Illinois Tollway Standard Drawing Revisions
--

Section A	Roadway Pavement	
Drawing	Modification Summary	Effective: 03-01-2026
A1-10	CONCRETE PAVEMENT REPAIR FULL DEPTH	
Sheet 1	Revised Roadway Plan detail to update tie bar locations and clarify that the Transverse Expansion Joint is existing; tie bars to be placed per Note 8.

**CONCRETE PAVEMENT REPAIR
FULL DEPTH**
VERSION: 2026-03 STANDARD: A1-10 SHEET: 2 OF 2

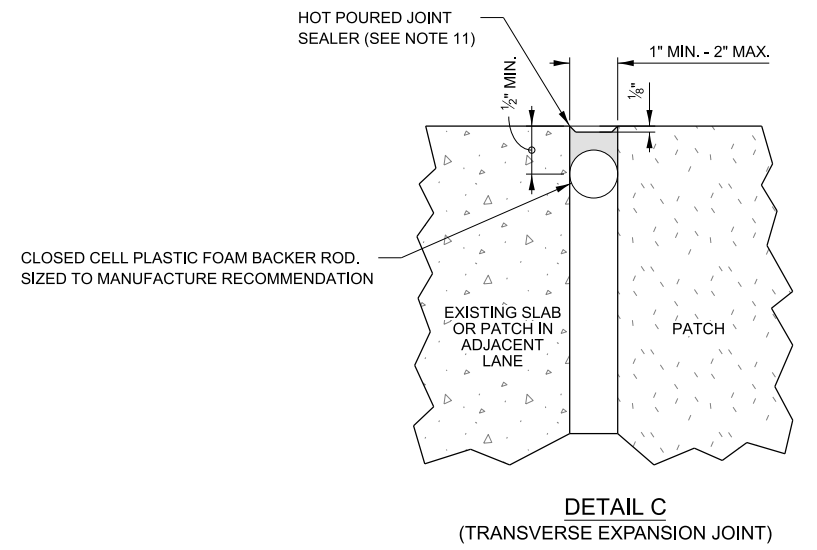
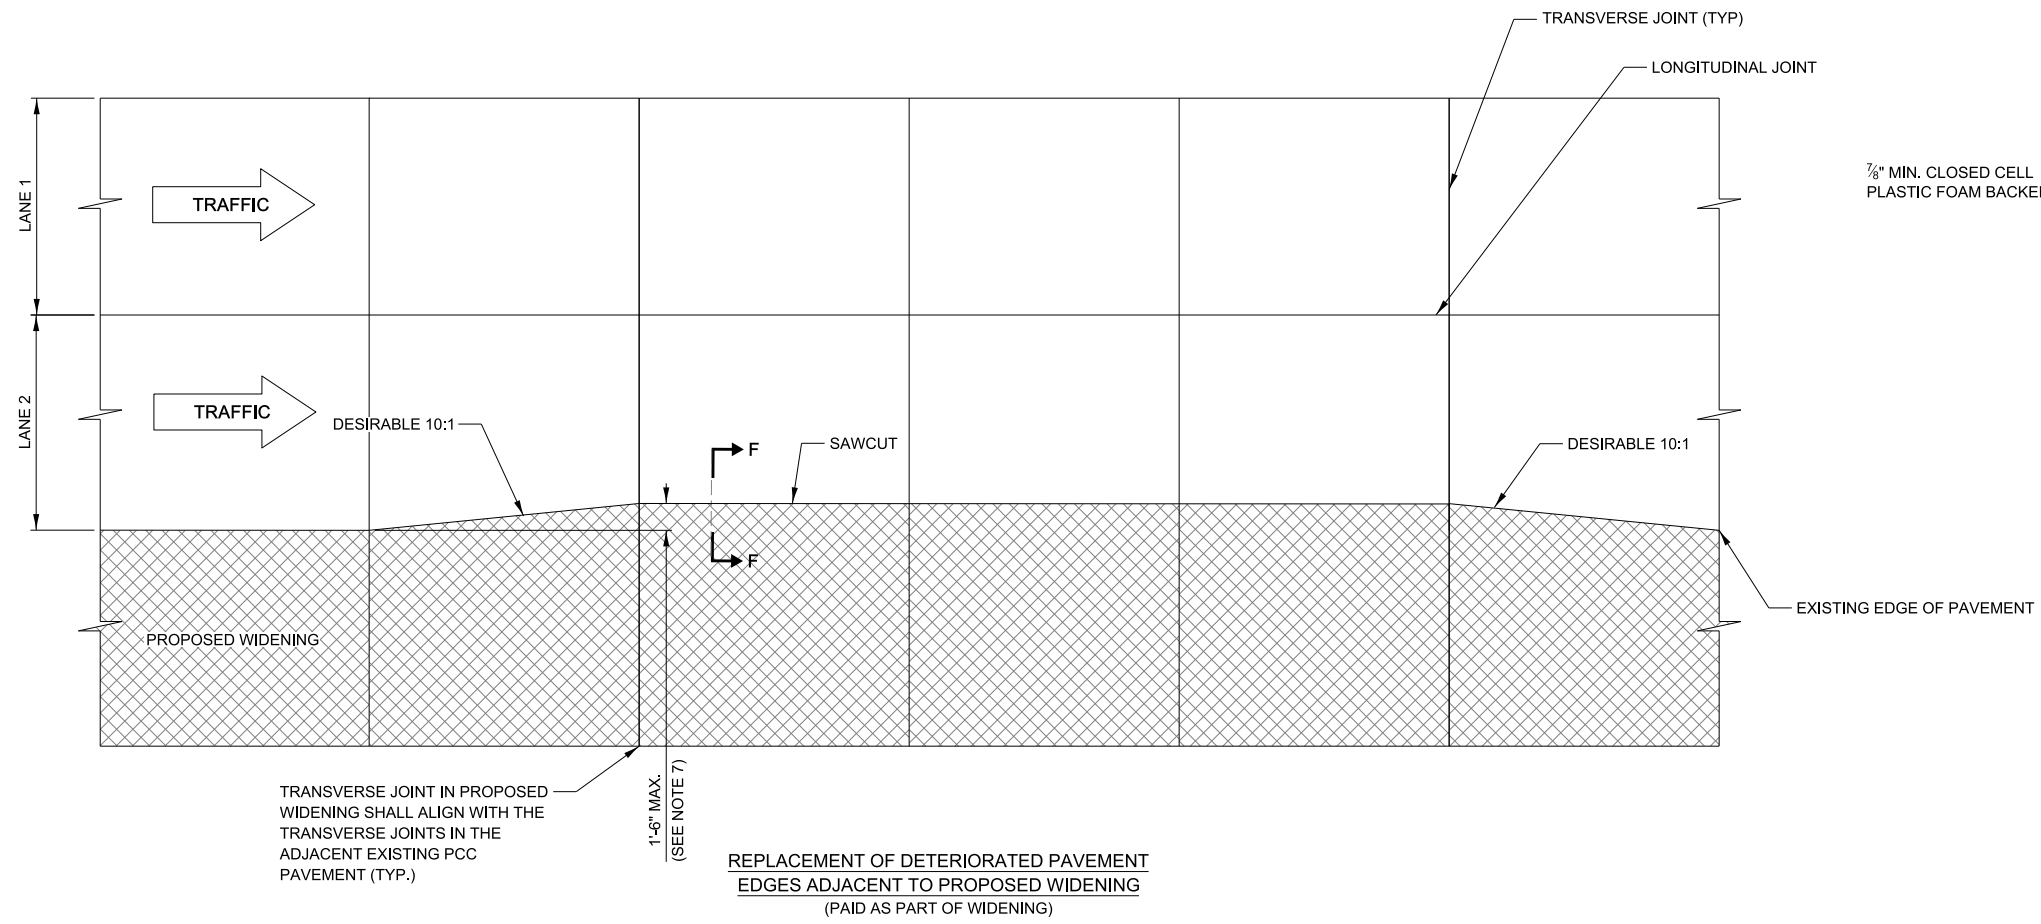
Sheet 2	Revised reference from Note 6 to Note 7, deleted Bond Breaker callout, and revised "1'-6" MIN" to "1'-6" MAX." in the "Replacement of Deteriorated Pavement Edges Adjacent to Proposed Widening" detail.	
	Deleted all references to Note 8 on this sheet.	
A7-07	PAVEMENT JOINTS

SLEEPER SLAB SECTION

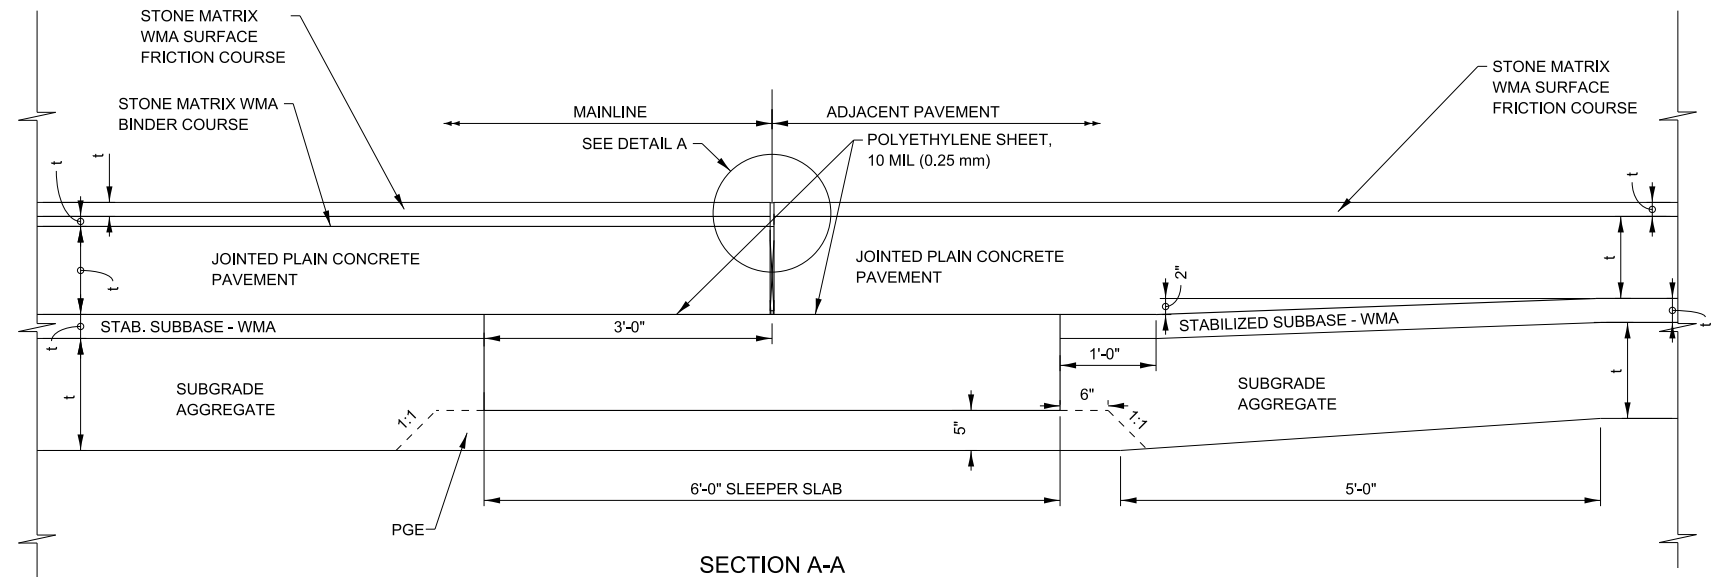
Sheet 1	Added a new note 2 to specify the spacing of the w(E) bars, in the Sleeper Slab Section Notes.	
A12-04	JOINTING PLAN ENTRANCE RAMP TERMINAL WITH AUXILIARY LANE

1. t(E) BARS SHALL BE PLACED AT 12" CENTERS.
2. w(E) BARS SHALL BE EVENLY (6" NOMINAL) SPACED CENTER TO CENTER.
3. w(E) NUMBER AND LENGTH DEPEND ON WIDTH OF ROADWAY.
4. USE 2'-8" MIN LAP FOR #4 BARS. USE 4'-0" MIN. LAP FOR #5 BARS.

JOINTING PLAN ENTRANCE RAMP TERMINAL WITH AUXILIARY LANE

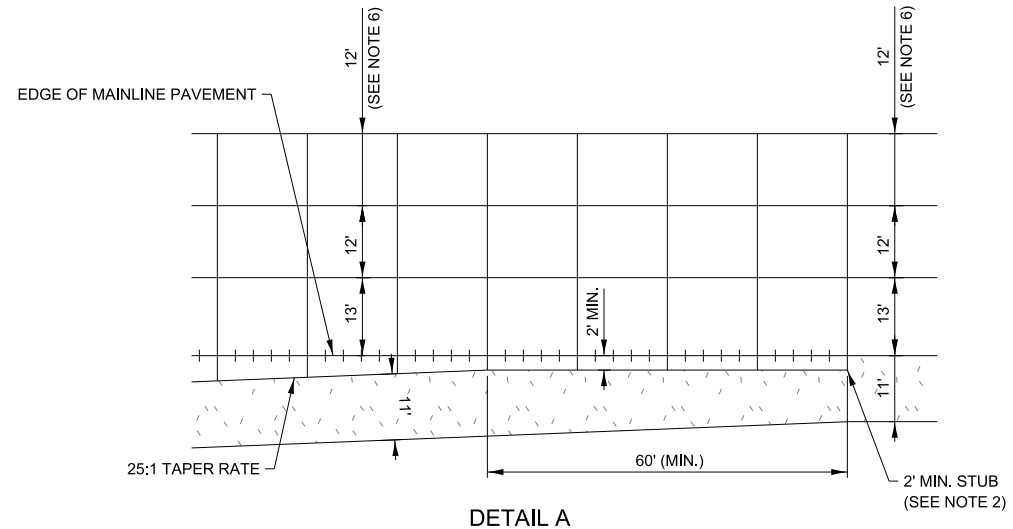
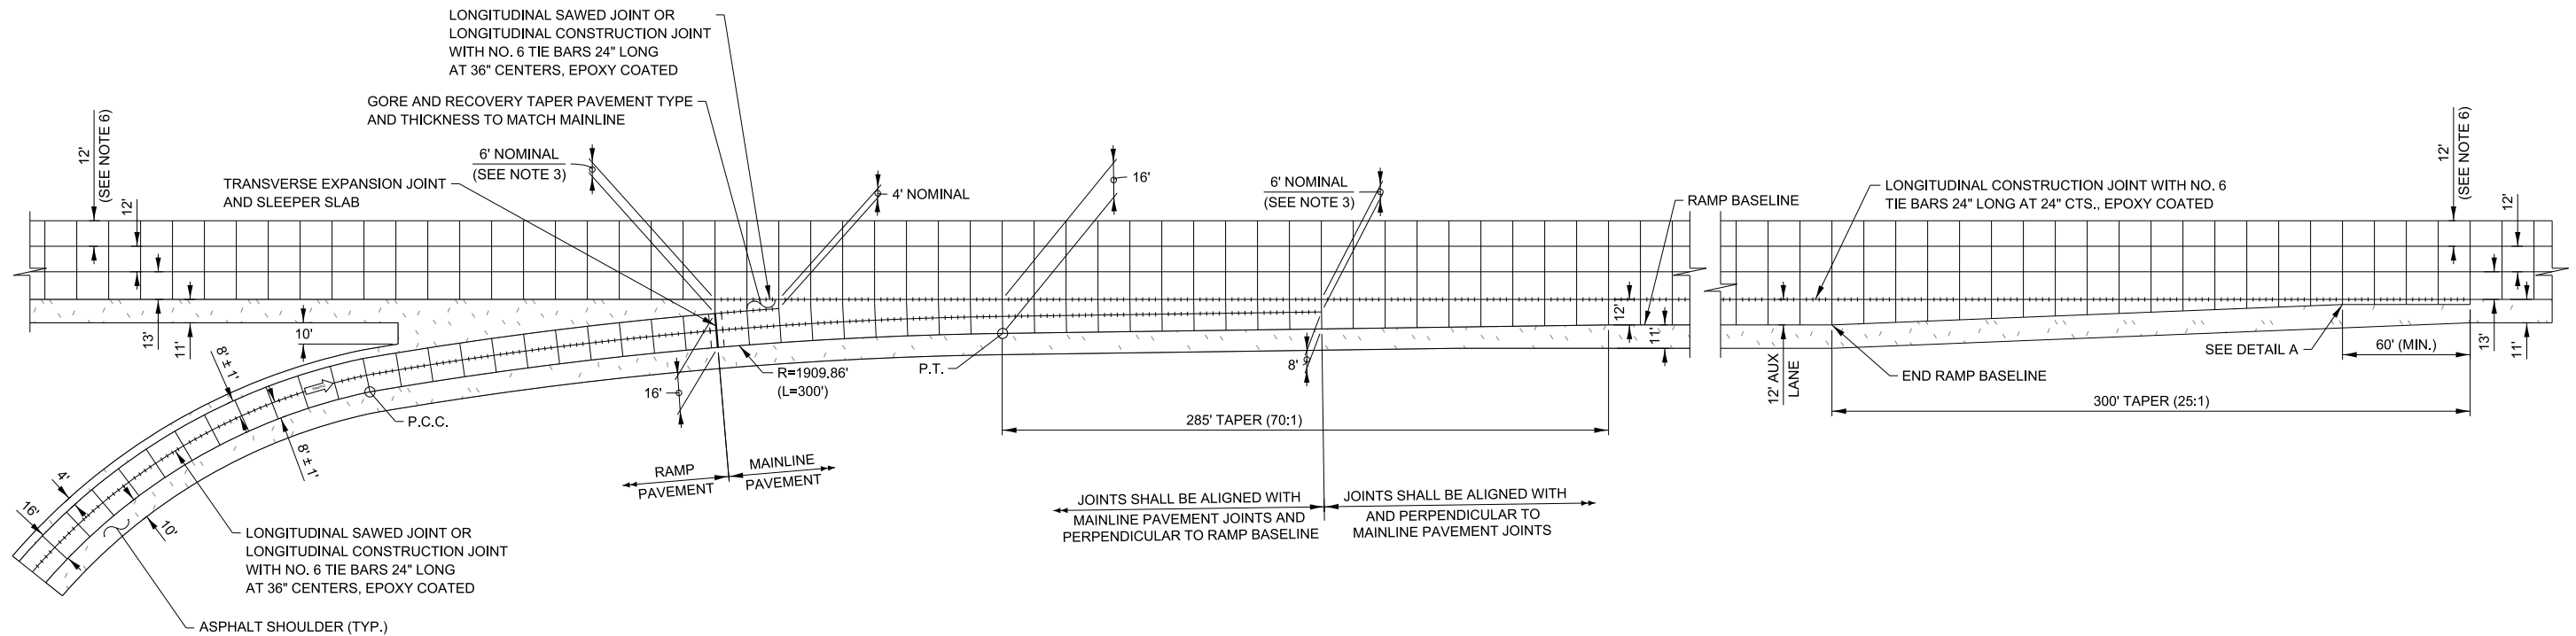
Sheet 1 and 2	Revised ramp length reflected in the updated plan drawing.	
A16-09	JOINTING PLAN PARALLEL EXIT RAMP TERMINAL LOOP RAMP ONLY	
Sheet 1	Added callout to identify the location of the center joint extending from the beginning of the ramp to the expansion joint.
